**Addendum to Sound Level Assessment
Hancock Wind, LLC
Hancock Wind Project
Hancock County, Maine**

Original Sound Level Assessment - January 2013

Addendum Date – June 2014

Prepared for:
First Wind Energy, LLC

Revised Figure 6-1. Predicted Sound Levels from Full Routine
Operation of Hancock Wind with V112 Turbine (Permitted Layout)

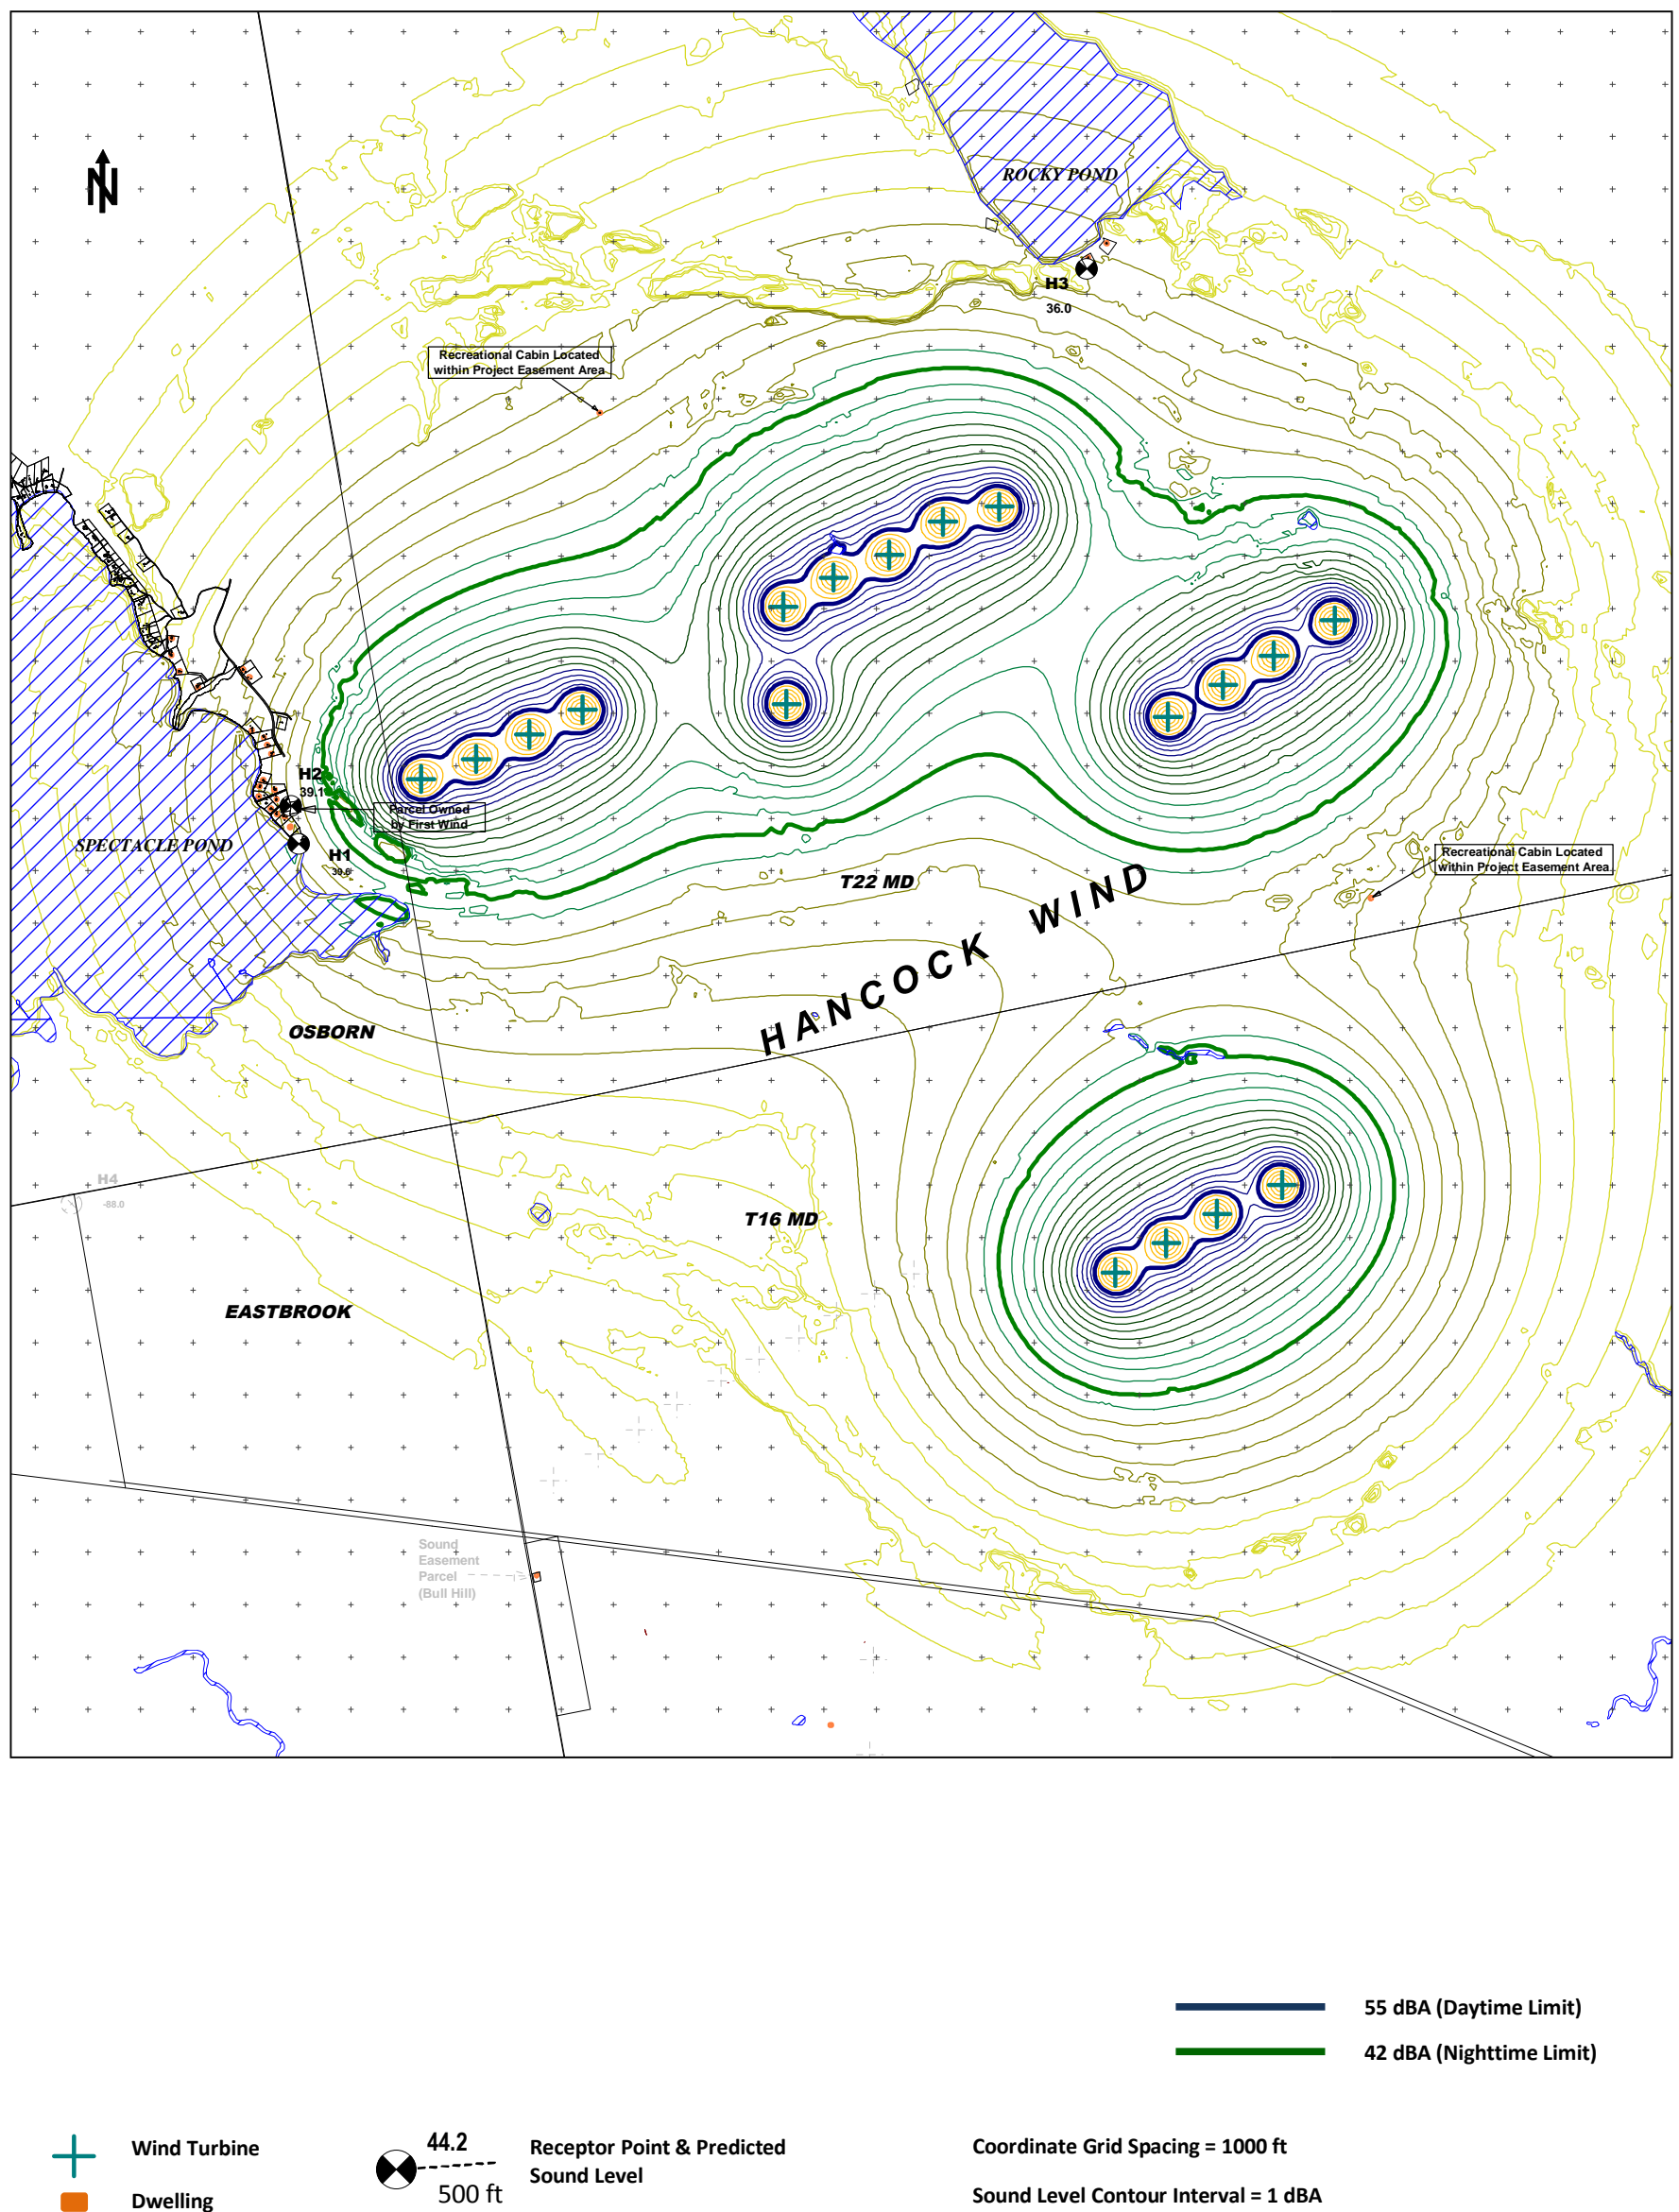
The January 2013 Sound Level Assessment inadvertently presented an earlier turbine layout than was contained in the civil design as permitted for the Project. This Addendum presents predictive model calculations for the permitted layout including a revised sound contour map for Hancock Wind and updated calculations for receptor points. As with the original Sound Level Assessment, this Addendum calculates predicted sound levels from simultaneous operation of all proposed wind turbines at maximum rated sound power output and during nighttime stable atmospheric conditions.

Figure 6-1 of this Addendum presents a map from the original Sound Level Assessment showing the turbine layout, sound level isopleths at 1 dBA intervals and predicted sound levels at selected receptor points for the V112 turbine. Revised Figure 6-1 shows the same information for the permitted turbine layout. The most notable changes occurred with four turbines located in the eastern most turbine group. Turbines 15 and 16 (see Revised Figure 6-1) were relocated to the southeast and Turbines 17 and 18 moved northwesterly with distances ranging from approximately 530 to 1330 feet. In both figures, the sound level contours corresponding to Maine DEP daytime limit of 55 dBA and nighttime limit of 42 dBA are shown as bold lines.

The revised calculations indicate that changes to the turbine layout were minor from a sound assessment standpoint and did not significantly affect the results of the predictive sound model or findings of the original study.
